## **MEMORANDUM OF STAFF COMMENTS**

RE: #2020-15 Yard Variance

APPLICANT: Kusum Shah (Owner/Member, Twin Spruce Motel, LLC)

ADDRESS: 697 Berlin Turnpike

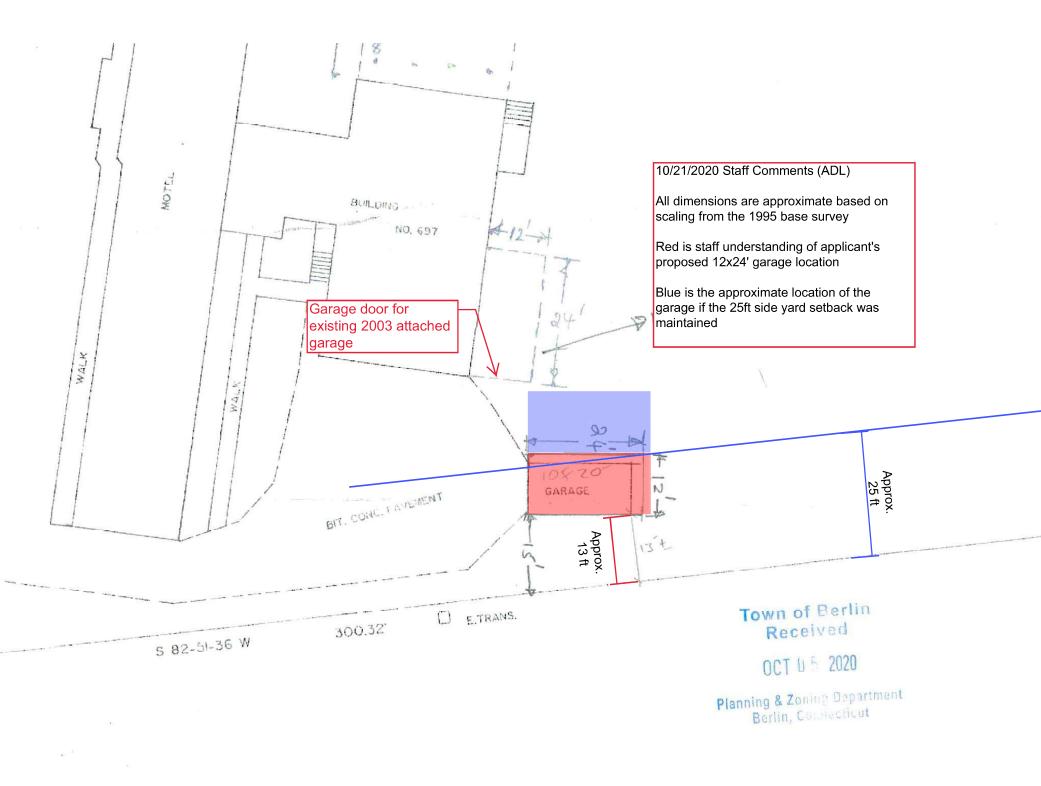
According to the town Assessor's card, the previously-demolished detached garage the applicant is proposing to replace was constructed in approximately 1988. The garage was located to the south of the 1973 split-level addition and a 2003 attached garage, and per the applicant, was destroyed by a storm in approximately 2019. Based on a 1995 survey, the garage was approximately 10 feet x 20 feet and located approximately 13 feet from the southernly side property line.

The proposed garage is four feet longer than the previously-demolished garage and would not meet current regulations for side yard setbacks. However, it would align with the previous nonconforming setback line of the demolished garage. See the attached staff plan markup for the proposed garage and setback information.

*§VI.J* Side Yard Required: 25 ft. Previously Existing Nonconforming: 13 ft. Proposed: 13 ft.
